## ORIGINATION FORM

Proposed Revisions to a Standard Plans Index  
(Please provide all information — Incomplete forms will be returned)

Index Number: 455-154  
Sheet Number (s): 1 of 3  
Index Title: 54" PRECAST/POST-TENSIONED CFRP & SS  
CONCRETE CYLINDER PILE

ELEVATION

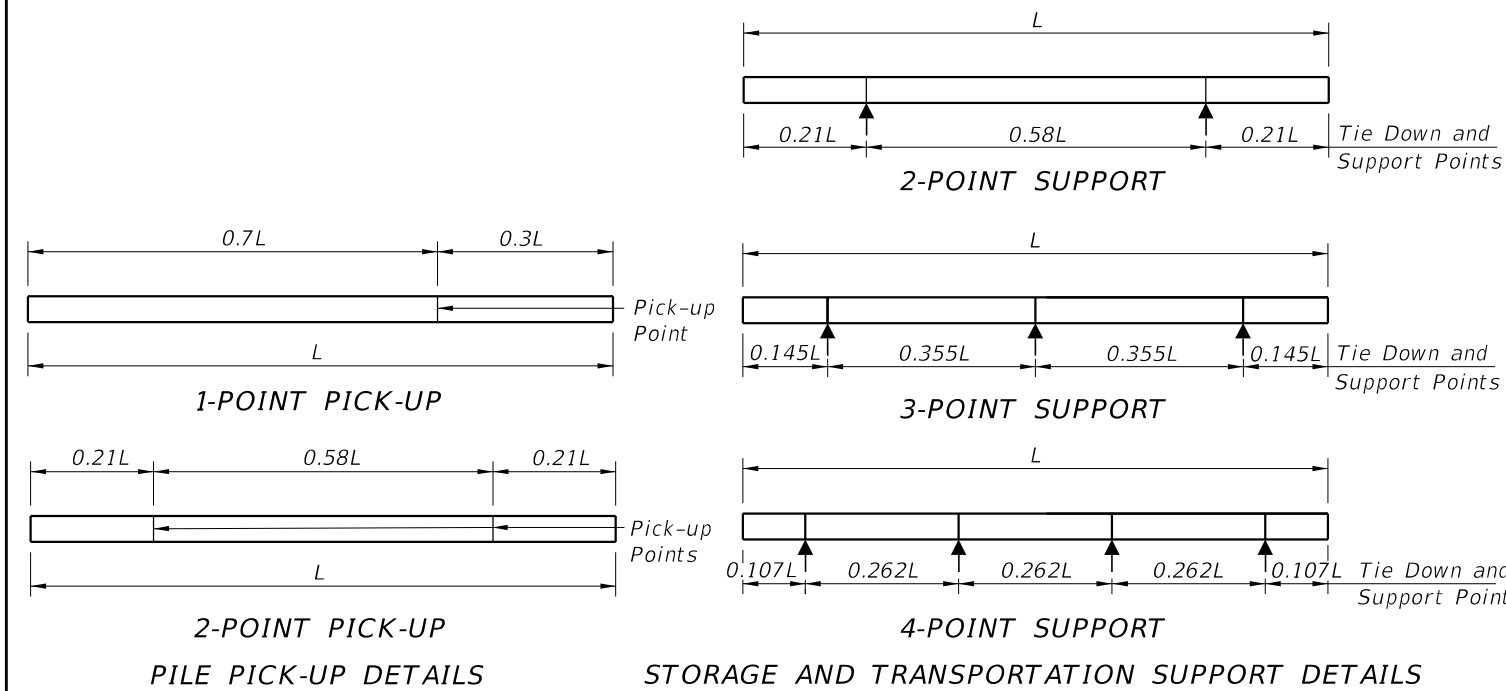
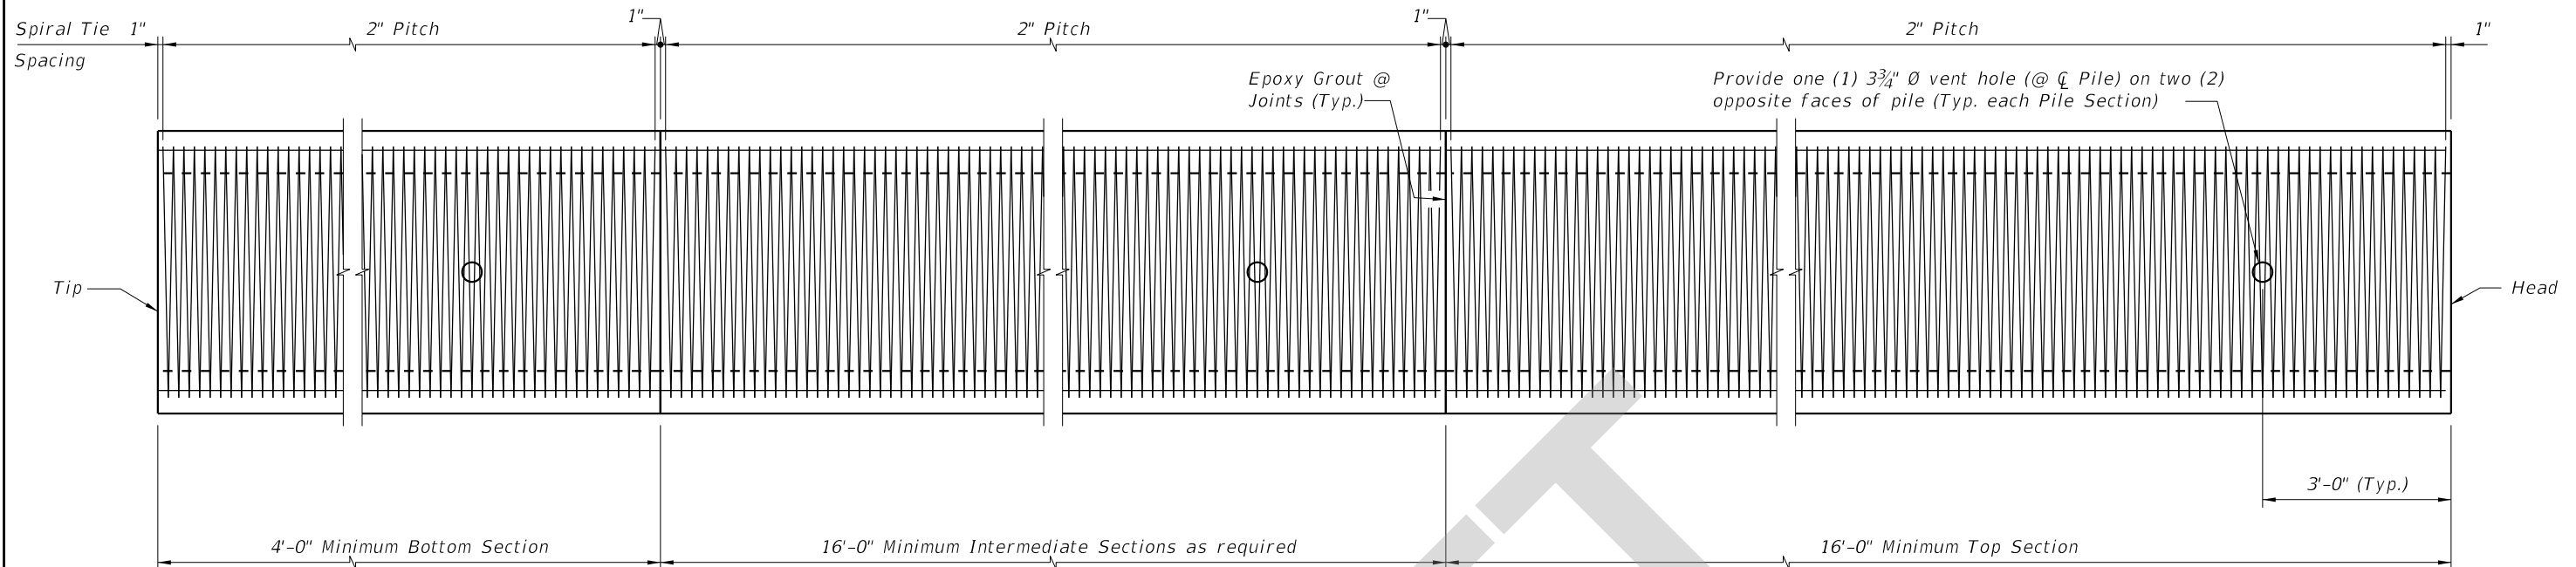
Sheet 1: Corrected note 3 language for clarity.

Sheet 1: We needed to correct the terminology so that it was clear that the value provided correlated to the application of prestressing force.

- Concrete Strength at time of prestress transfer: **application of the prestressing force:**
  - Piles: 6,000 psi minimum.
- Reinforcing:
  - Bars:
    - Stainless Steel: Meet the requirements of Specification Section 931 for Type 304, Grade 75.

3. Concrete Strength at time of application of the prestressing force:
  - A. Piles: 6,000 psi minimum.
4. Reinforcing:
  - A. Bars:
    - a. Stainless Steel: Meet the requirements of Specification Section 931 for Type 304, Grade 75.
